STEP BY STEP EARLY LEARNING CENTER	EXISTING CONDITIONS
---------------------------------------	---------------------

STEP BY STEP
EARLY LEARNING CENTER
DEMOLITION & TESC PLAN

C3.01

C3.10

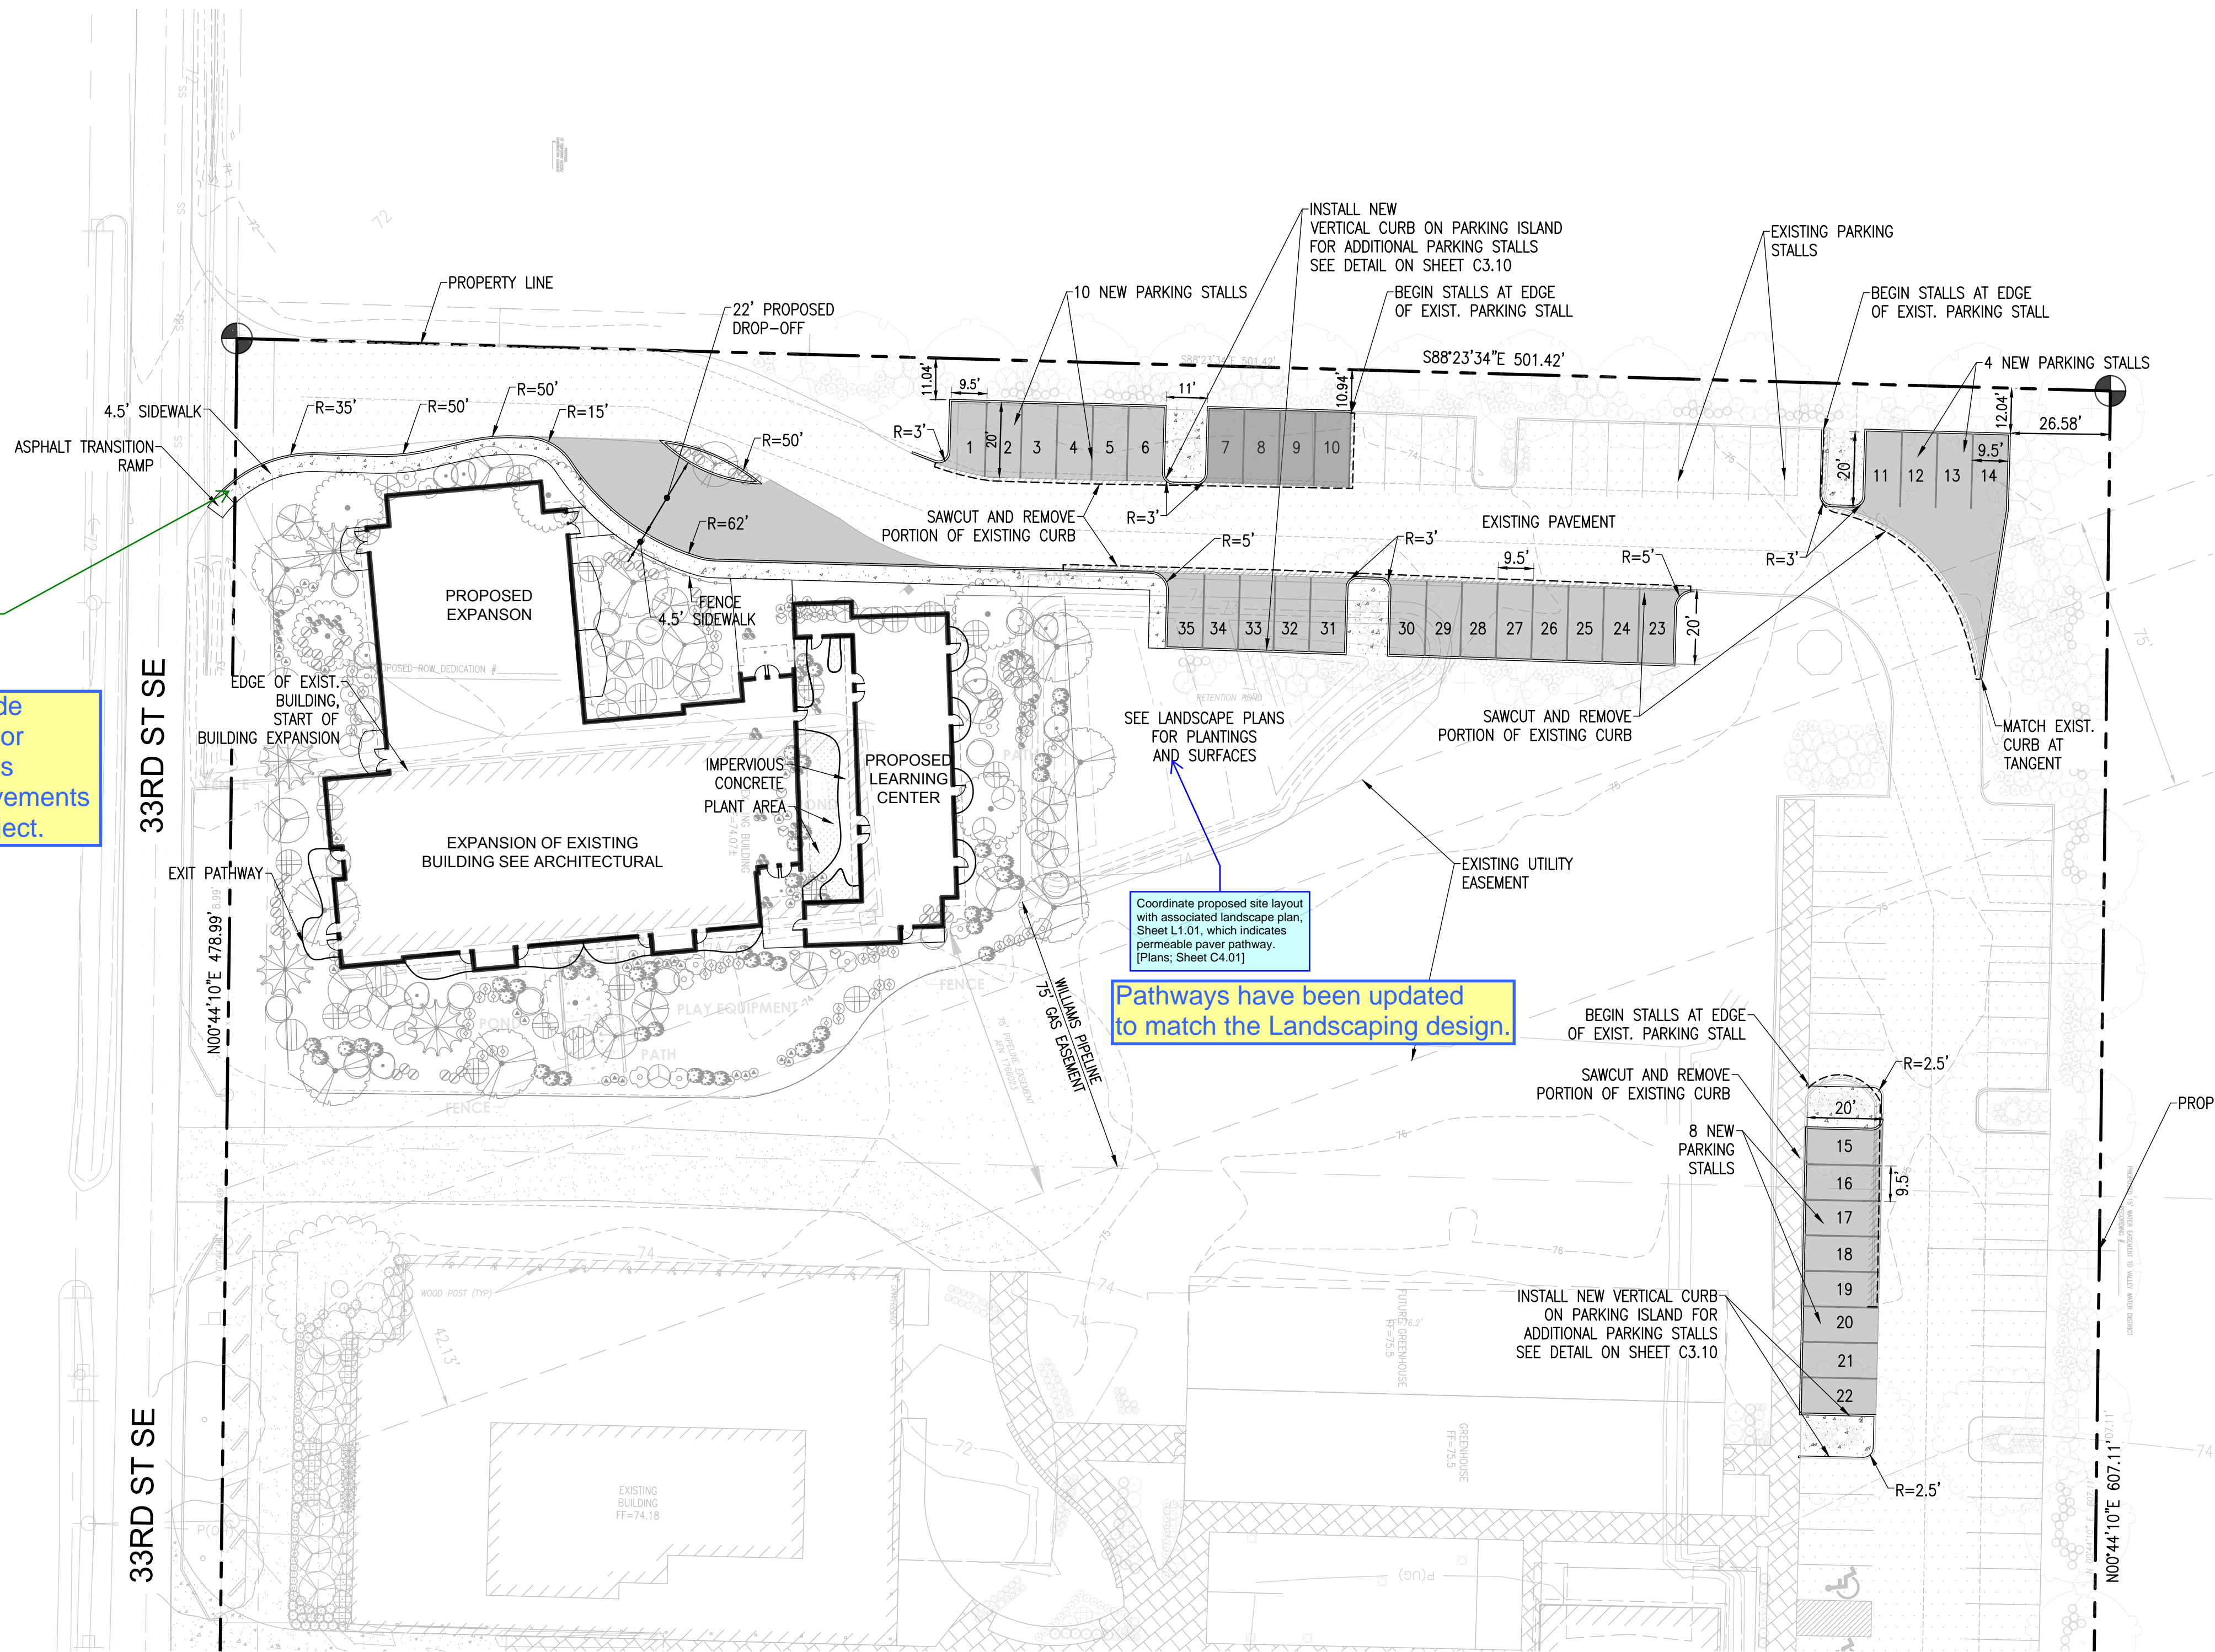
Please add CB filter sock detail.
[Plans, Sheet C3.10]

CB filter sock detail
has been added.

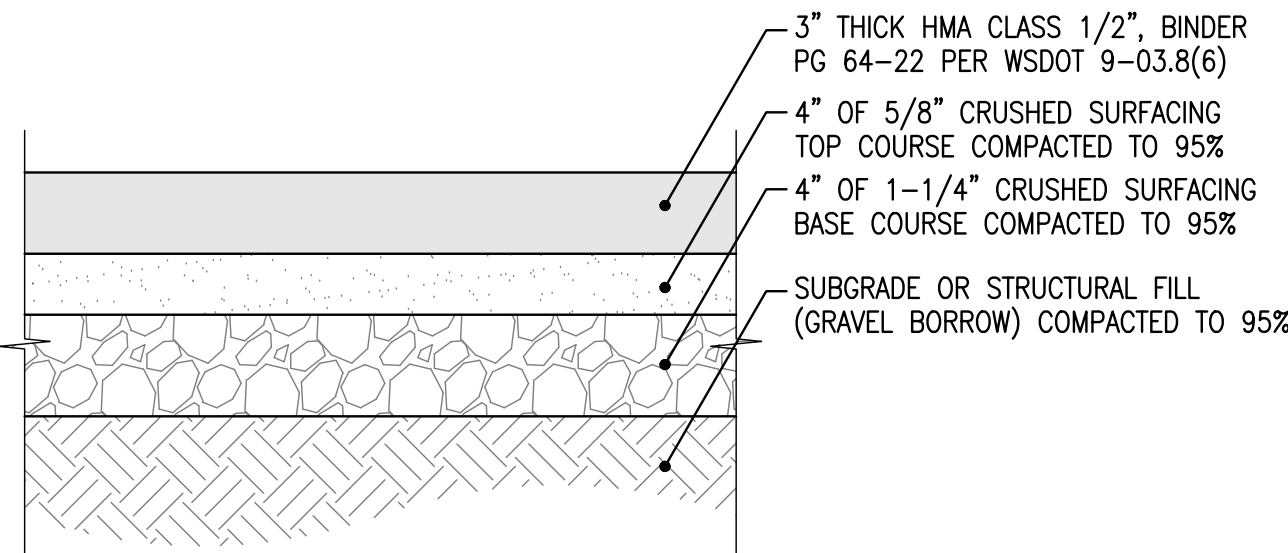
where is this sidewalk going, should there be frontage improvements if they are directing pedestrians to this unimproved road...at a school SH C4.01

Coordinate proposed site layout with associated landscape plan; Sheet L1.01, which indicates permeable paver pathway. [Plans; Sheet C4.01]

The sidewalk and curb provide a grade separated walkway for vehicles dropping off students at the ELC. Frontage improvements are not proposed for this project.

Pathways have been updated to match the Landscaping design.

STORM DRAINAGE DETAILS

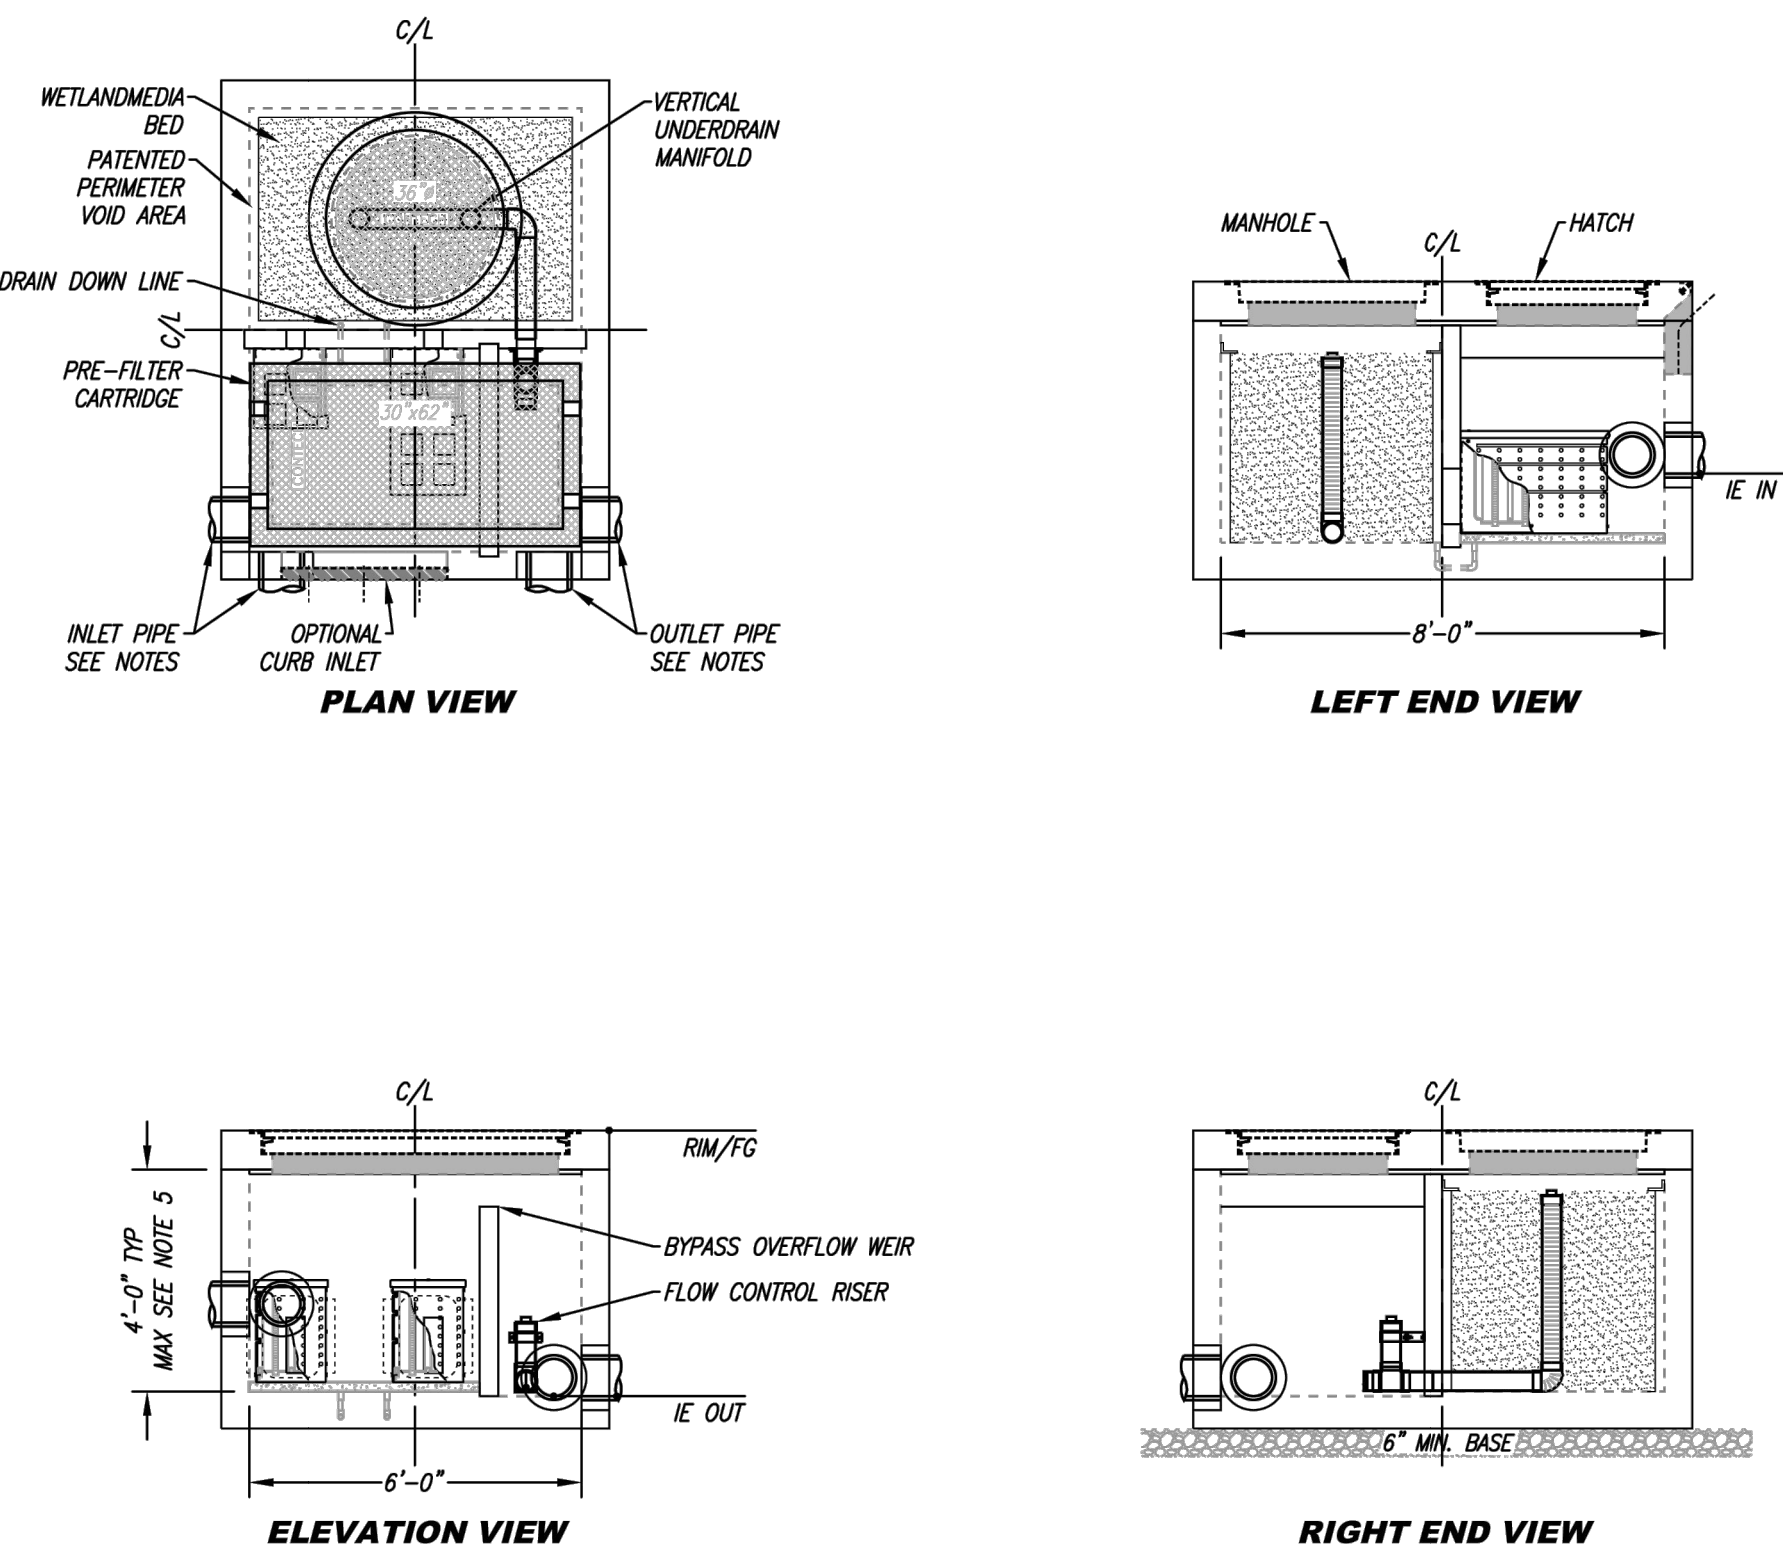
Add City Standard Details:
02.01.01 // 02.01.03 // 06.01.02 // 06.01.03 // 06.01.04
[Plans; Sheet C5.10]

All details have been added.
